SUNDALE DEVELOPMENTS

12-16 BENT STREET - LINDFIELD

LANDSCAPE RESPONSE TO SDRP REVIEW 2 (2 APRIL 25)

S24-01924 • 25/09/2025

Drovers Way (New Lane)

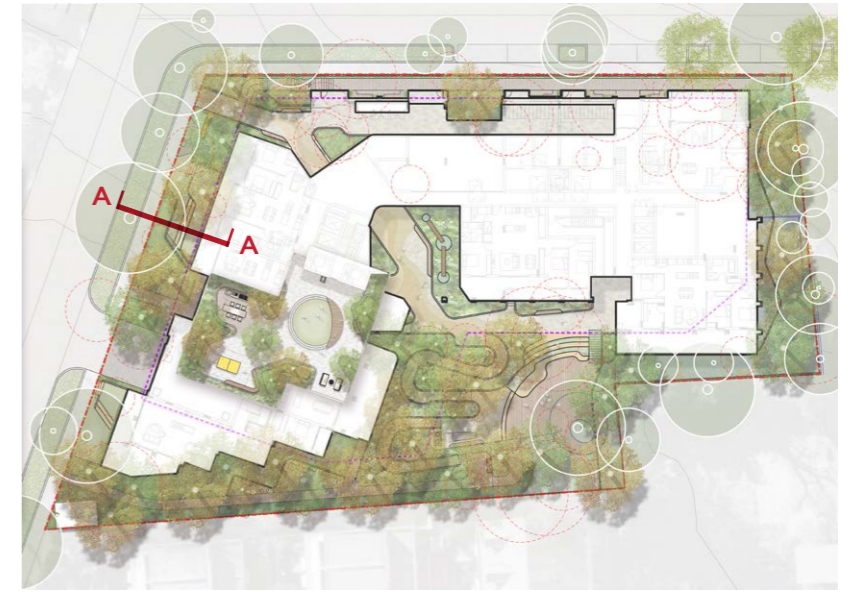
- The Amphitheatre area includes hardstand areas and structures. Consequently, the deep soil area should be re-calculated excluding this portion of the site.

- The current deep soil calculation includes the suspended decking area, this can be seen as deep soil as it allows for water infiltration and does have connected soil underneath. Deck footings have minimal impact (pile footings). Refer to page 15 for information on permeable surfaces and suspended structures.
- Refer to Section BB and the 3D modelling image on page 18 for details demonstrating how deep soil can still be provided in the amphitheatre area.

Section AA

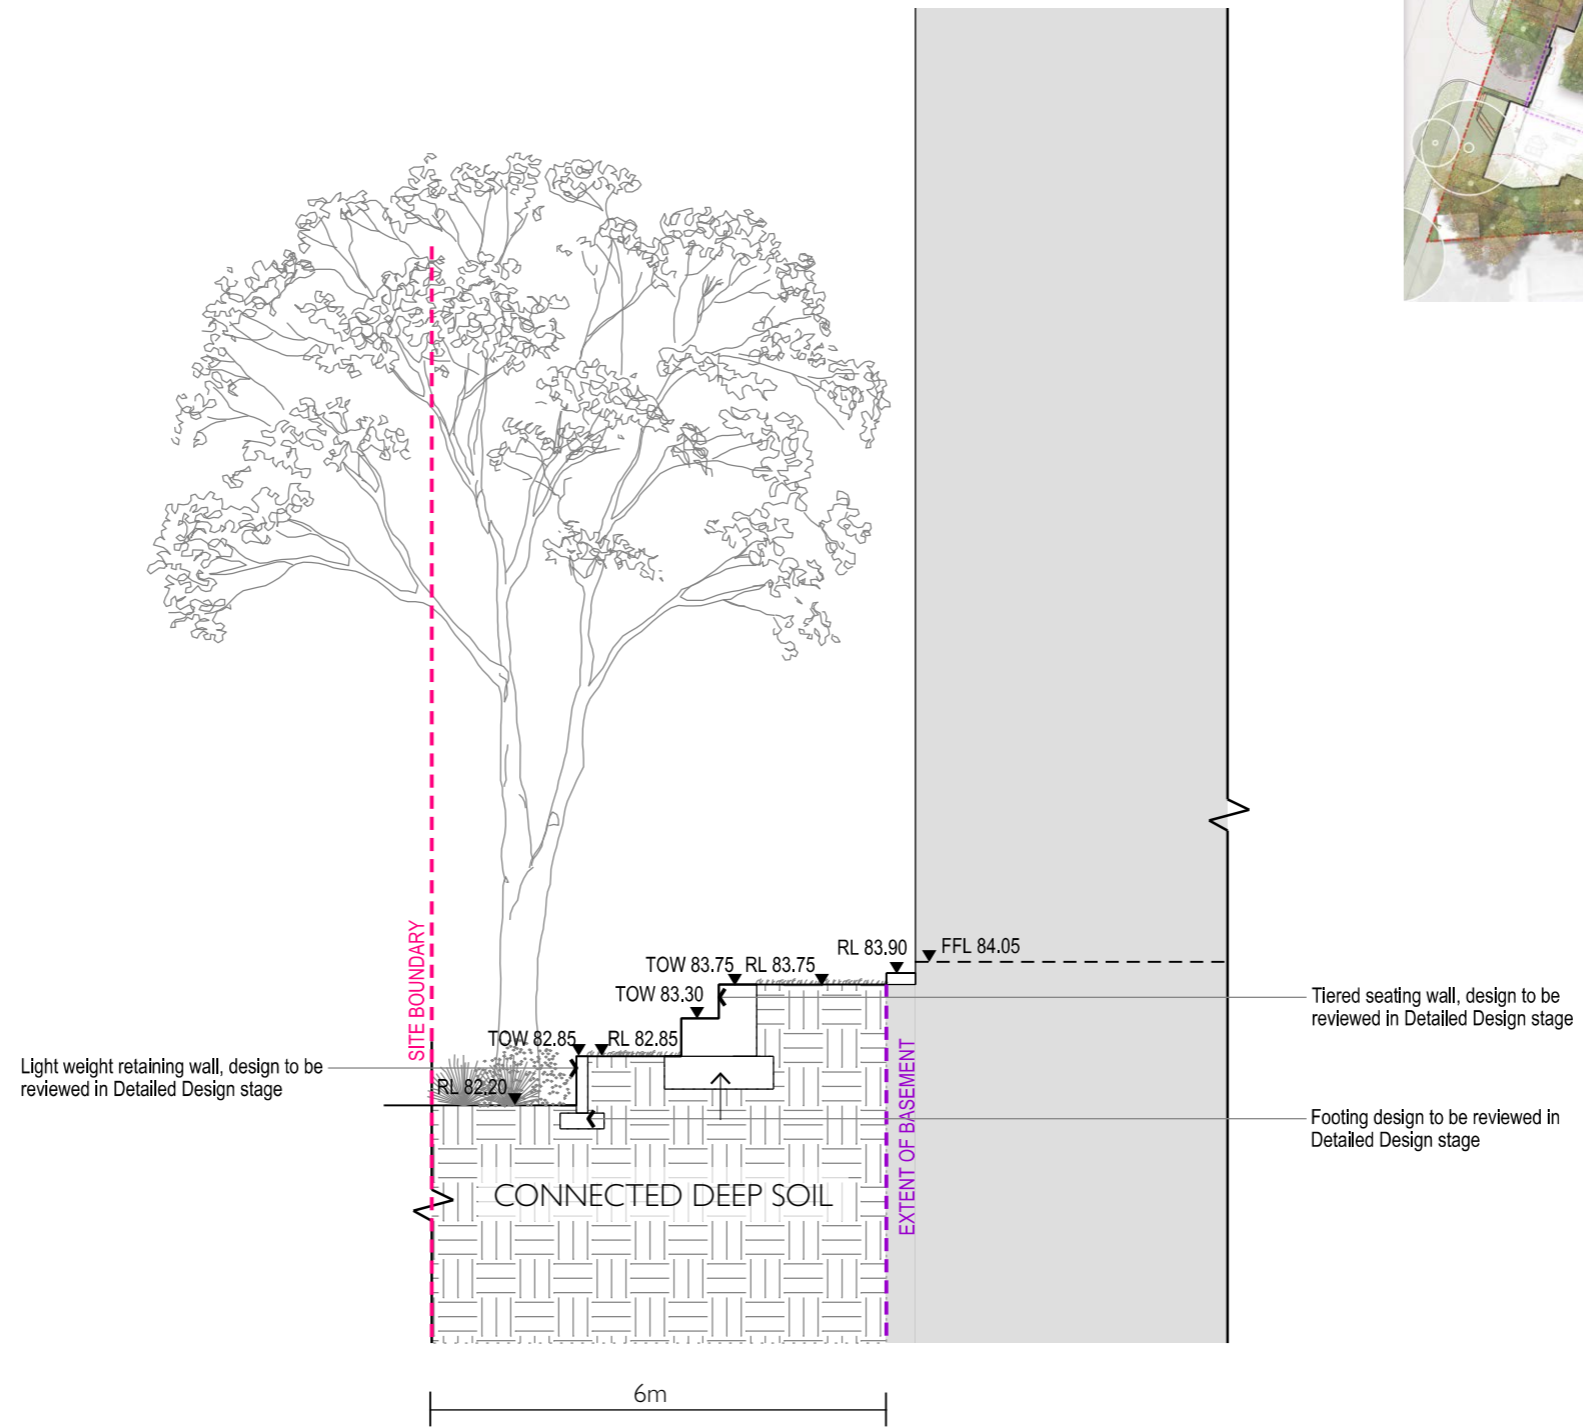
- The submitted plans and calculations incorrectly include areas as deep soil that are inconsistent with the ADG definition, with calculable areas including areas less than 6m in width, impervious areas, services and structures. The eastern 6m deep soil pocket is divided by two retaining walls and therefore not 6m in width; the southern setback is divided by a retaining wall and therefore not 6m in width; the south-western area has extensive impervious paving and a retaining wall; and the northern setback has a retaining wall, services, structures and impervious paved areas and is therefore not 6m in width in part, resulting in only three small individual and isolated pockets that fail to meet the minimum deep soil zone area requirements.

- Section AA on page 17 illustrates the underground soil volumes at the Bent Street frontage remain connected, despite being divided by tiered seating walls and a lightweight retaining wall.

Section BB

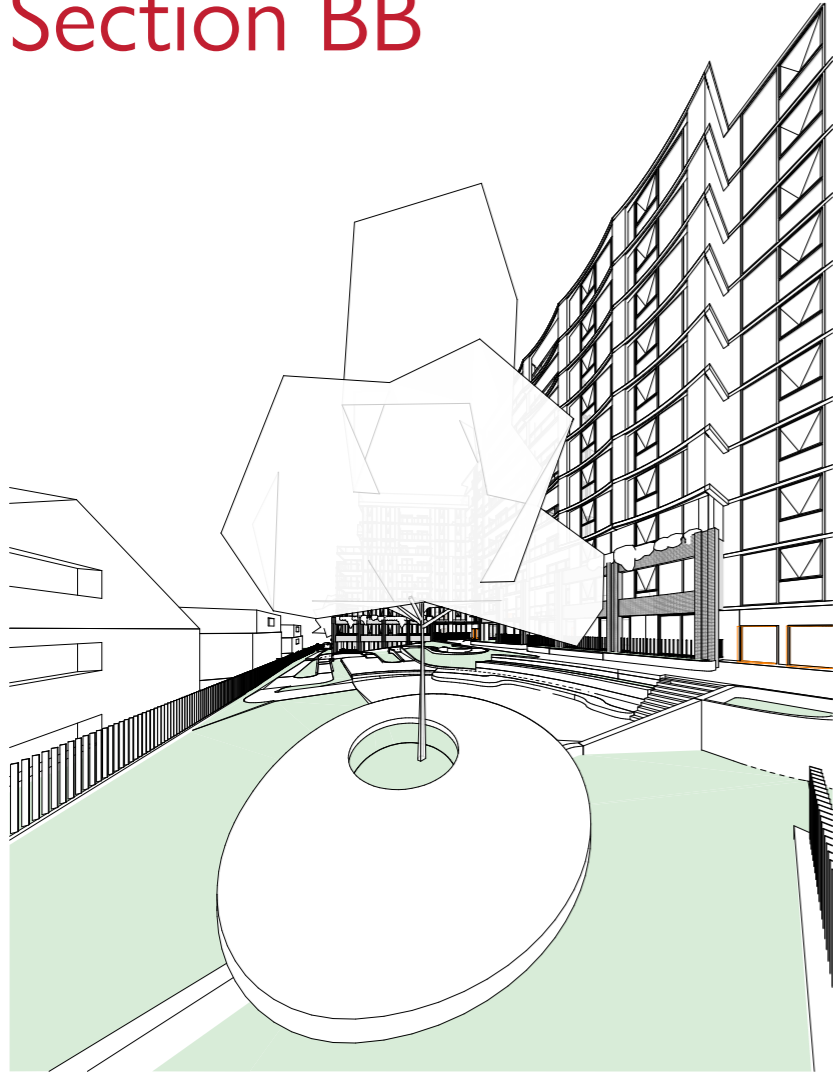
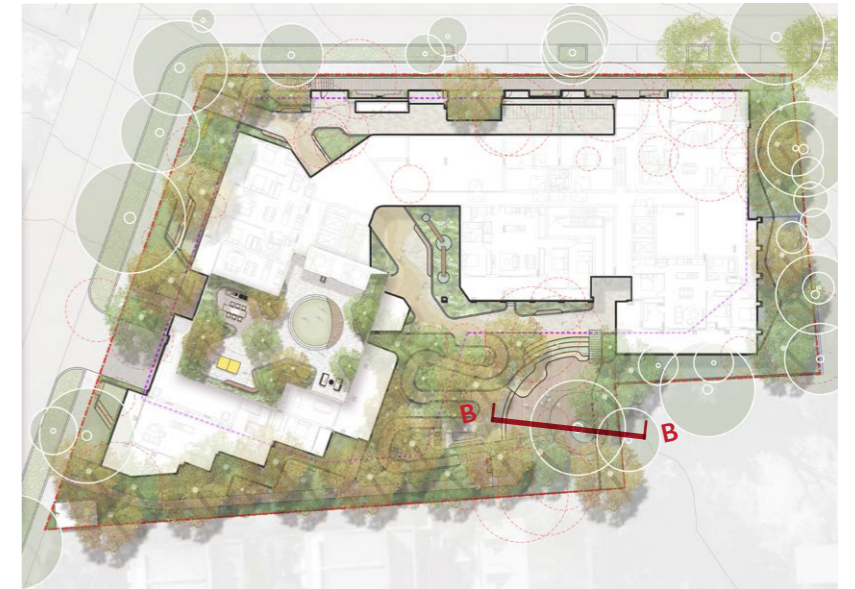
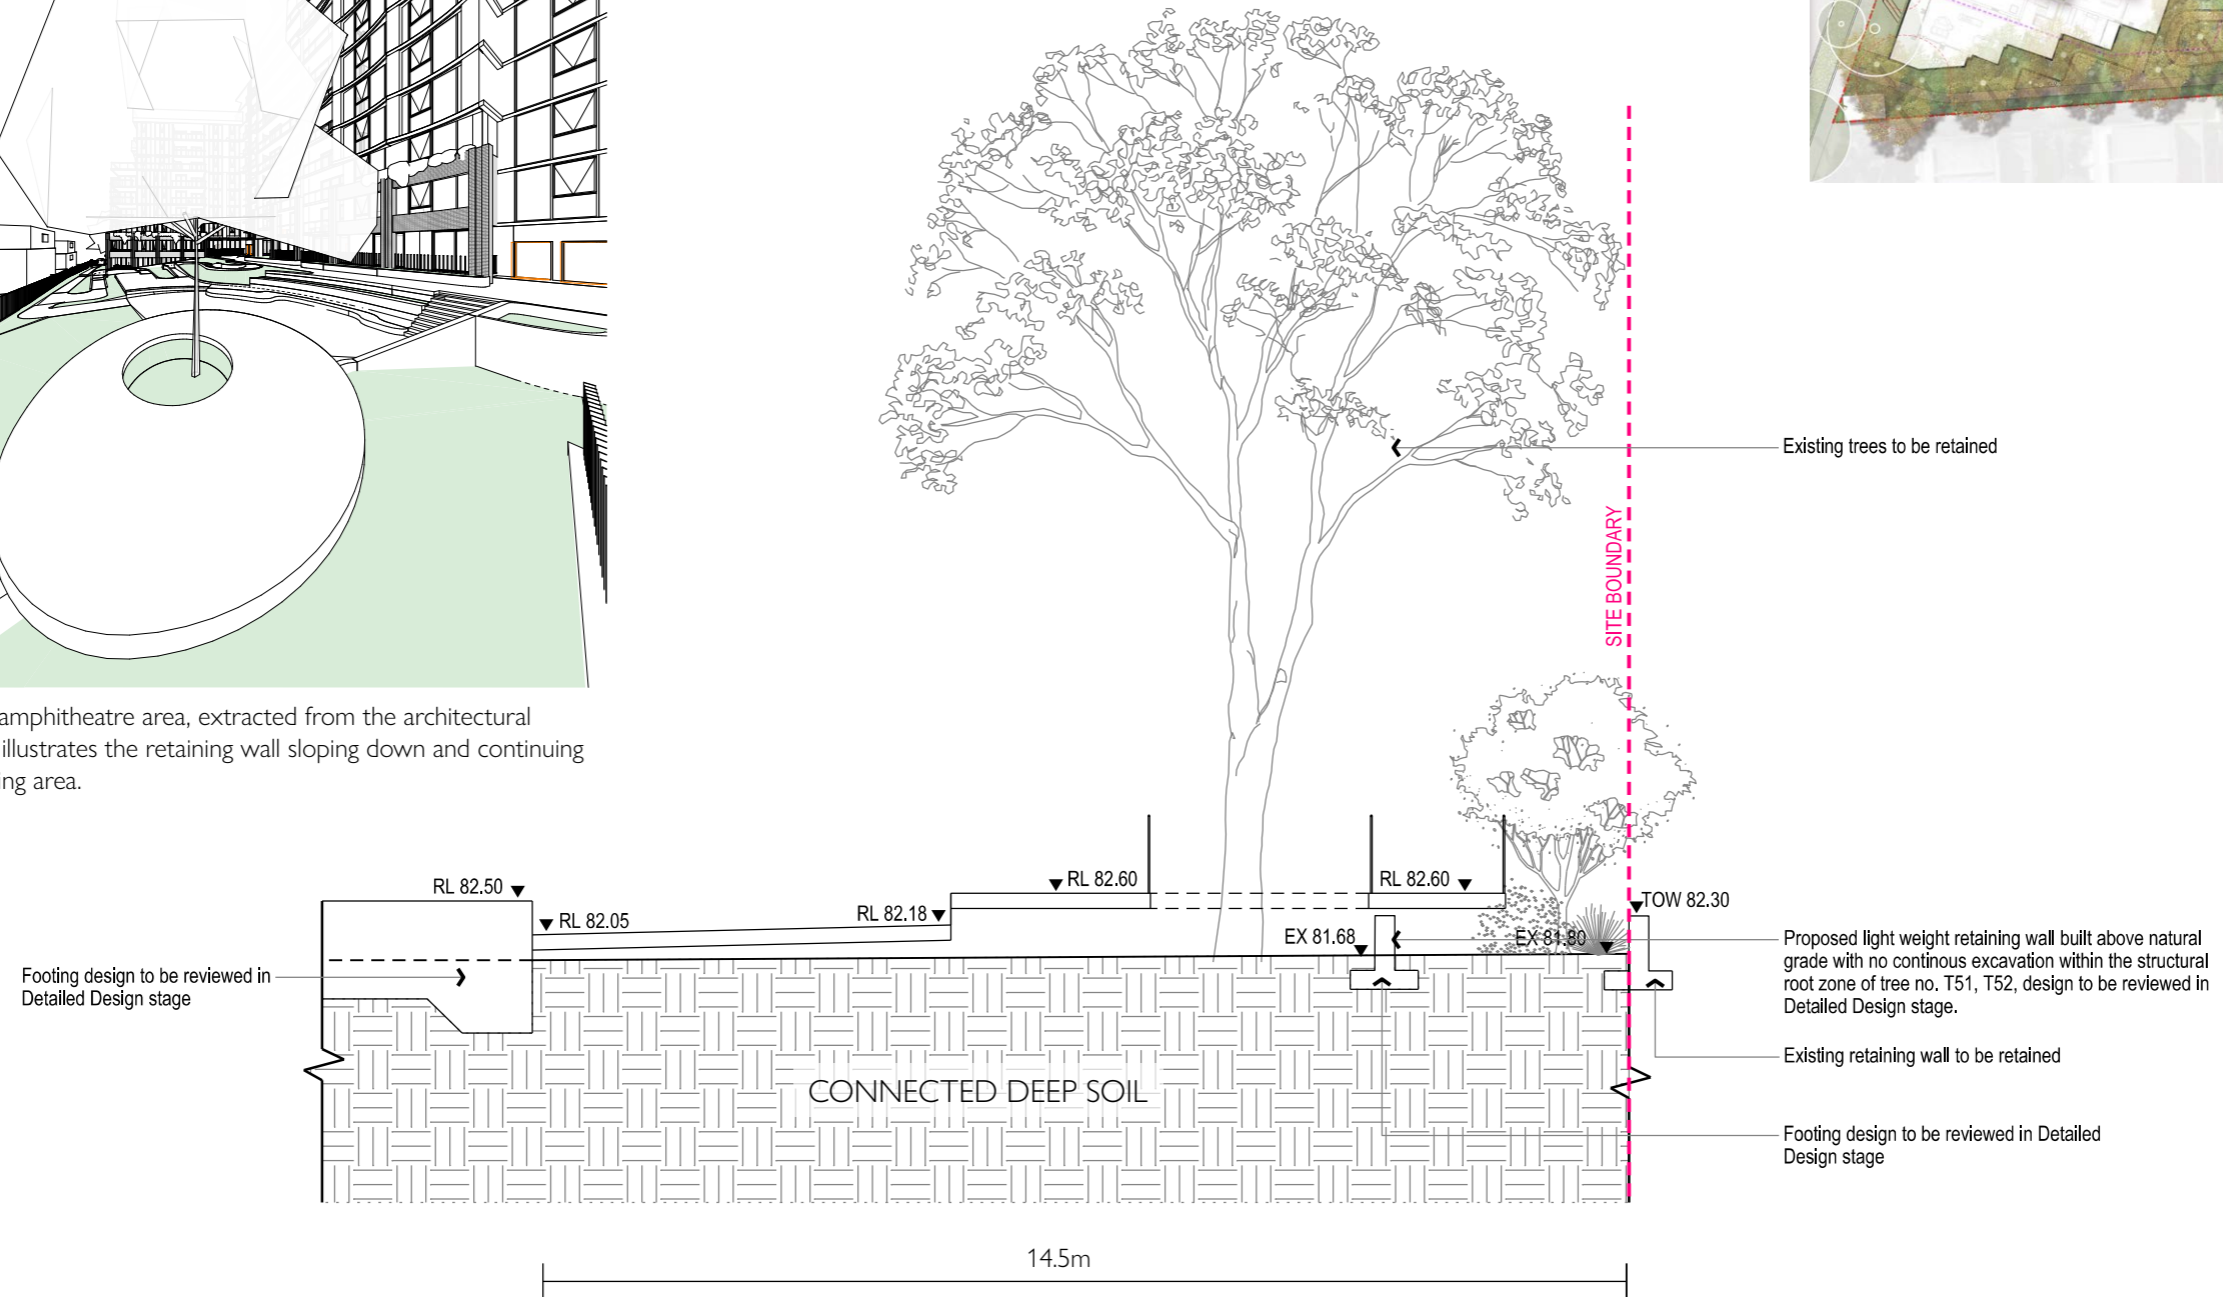
- The retaining wall for the overland flow path appears to be located in the outdoor Amphitheatre area. Please clarify how both elements are intended to be designed and integrated within the same space.
- Confirm whether the materials proposed for the Amphitheatre will be waterproof and consider using materials that can withstand the overland flow through this area.

- Section BB and the 3D modelling image on page 18 illustrates the underground soil volumes at the amphitheatre area remain connected, despite being divided by a retaining wall.

3D modelling of the amphitheatre area, extracted from the architectural drawings. This image illustrates the retaining wall sloping down and continuing underneath the decking area.
